FINGAL CYCLING

It is unfortunate to see that the Snugborough Interchange Scheme appears primarily designed to make private motor car usage more attractive for residents and visitors by increasing vehicle flow. This does not meet the design requirement as laid out in section 2.2.2 User Priorities in the Design Manual of Urban Roads (DMURS):

Figure 1 Illustration of BusConnects CBC05 Joining Snugborough Junction

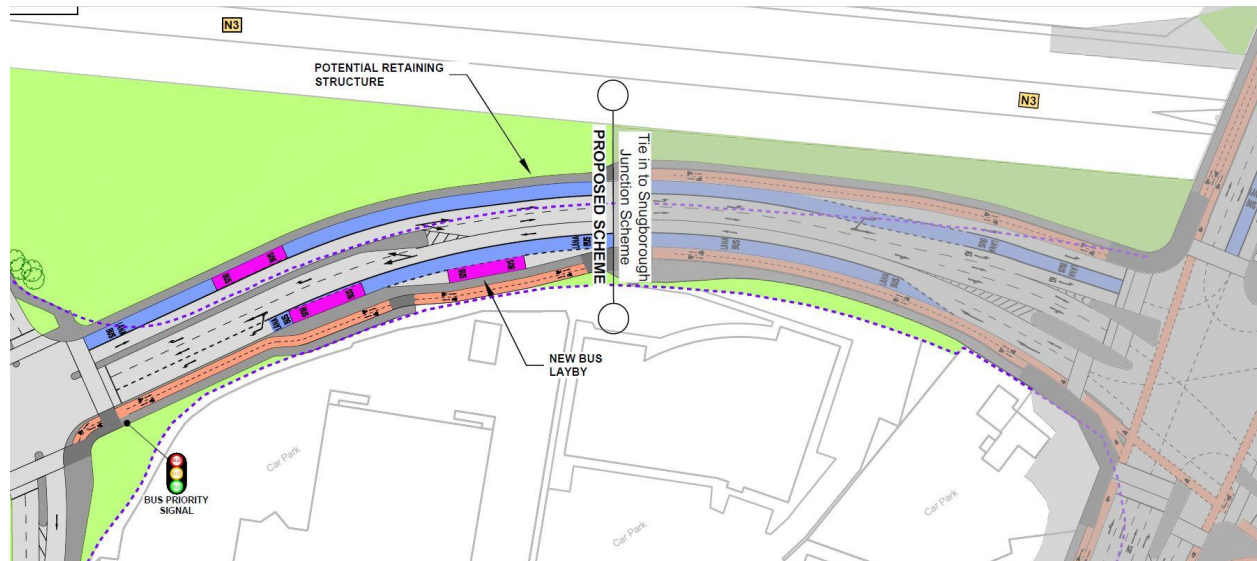
Figure 1 sums up the lack of accommodation for pedestrians and cyclists in the Snugborough Junction Interchange. The two-way cycle path coming from Blanchardstown Shopping Centre will flip from cycling on the left to cycling on the right all the while forcing pedestrians to cross the direction of travel of cyclists. The southbound cycle lane abruptly ends in a shared pedestrian space (use not recommended in National Cycling Manual section 1.9.3) before the junction itself, inevitably leaving cyclists stranded.

The two-way cycle lane on the east side of the road continues to force cyclists to cycle on the right. It provides no clear route for cyclists to continue on over the bridge as it abruptly ends in a shared pedestrian space. Furthermore, there is no direct southbound cycling route connecting Blanchardstown Village and Blanchardstown Shopping Centre.

Figure 5 Schematic Detailing Lack of Direct Access to N3 Cycling Underpass

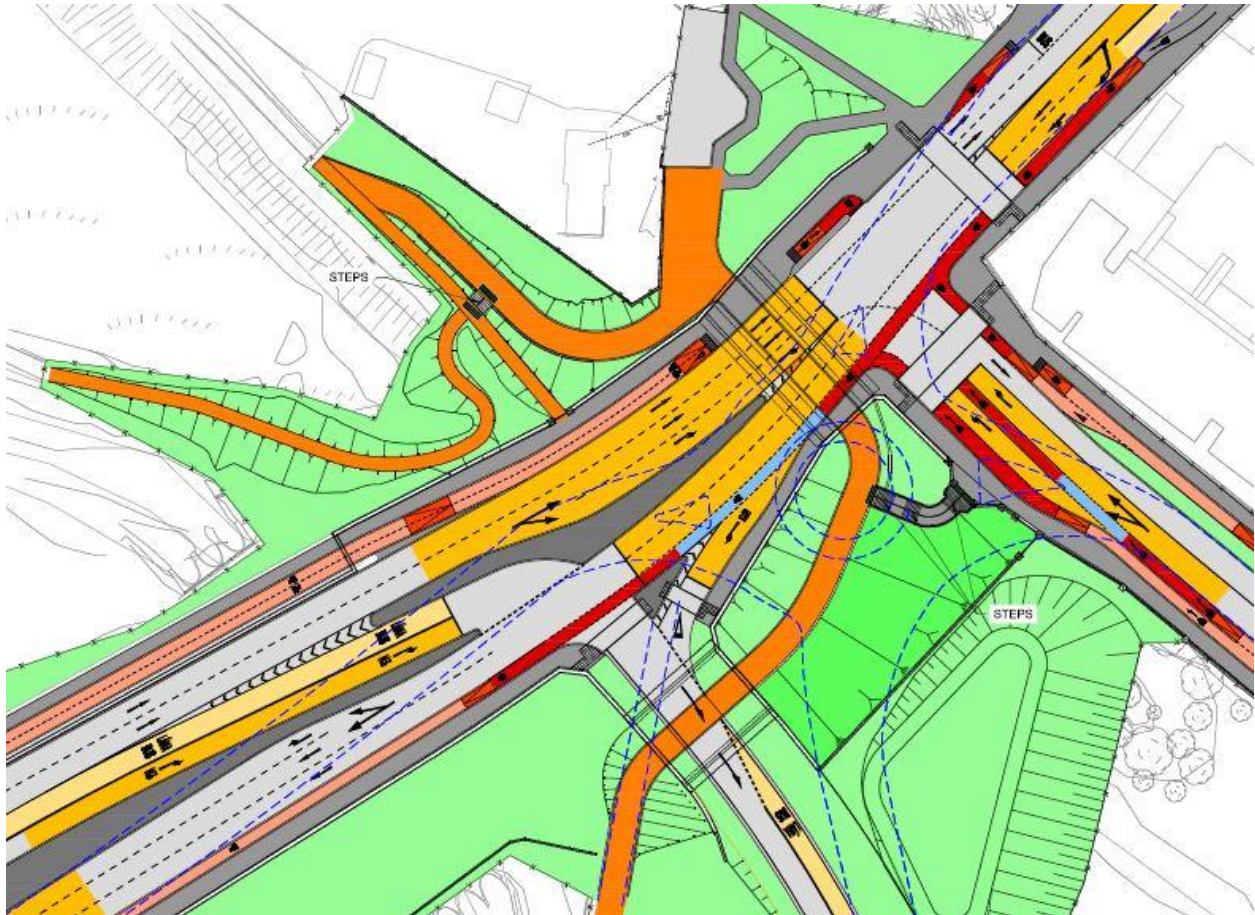
Cyclists wishing to cycle from Blanchardstown Shopping Centre to Blanchardstown Village are forced to cycle away from their destination. They then must negotiate shared space with pedestrians to connect to the cycling underpass. There are no clear indications to direct cyclists travelling from Blanchardstown Shopping centre to the village to the underpass.

The journey from the Ebay Offices southbound through Snugborough Interchange to the junction of Clonsilla Rd and R806 takes approximately two minutes. The proposed alternative route will triple the journey time.

Providing cycle lanes across slips lanes is not recommended by the NTA's National Cycle Manual (section 4.4.4). These slip lanes should be removed (DMURS 4.4.3) or converted into pocket turns where complete slip lane removal isn't possible. Furthermore, these slip lanes increase crossing movements for pedestrians and significantly increase the risk of injury to cyclists. The slip lane on Waterville Rd (Figure 5) unnecessarily prioritises vehicles over cyclists. The slip lane onto the N3 from the Snugborough Rd doubles the crossing movements for pedestrians and directs vehicles travelling at significant speed across the path of cyclists. These cycle lanes across slip lanes are known as "Murder Strips." This can easily be resolved by removing these dangerous and outdated slip lanes.

Figure 6 Schematic Illustrating Absence of a Southbound Cycle Lane From Blanchardstown Shopping Centre to Blanchardstown Village and a Shared Northbound Cycle Lane.

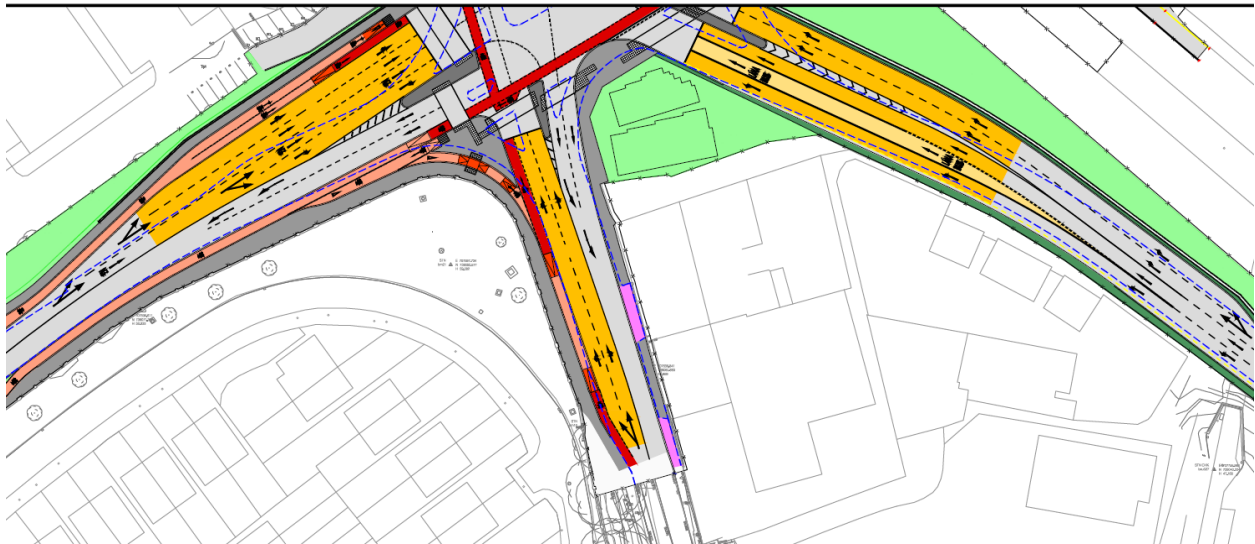
The northbound cycle lane from Blanchardstown Village (Figure 6) is either sharing space with pedestrians or a cycle lane that shares the space with vehicular traffic. This section will significantly increase the risk to cyclists travelling to Blanchardstown shopping center/Ben Dunnes Gym. The same applies for people who cycle heading west from Coolime along the Snugborough road. The cycle lane goes from segregated to shared at the junction where it

is most vital. The left turn is unprotected onto L3020 to Ben Dunnes Gym Westpoint and Blanchardstown shopping center and leave cyclists vulnerable to left turning vehicles.
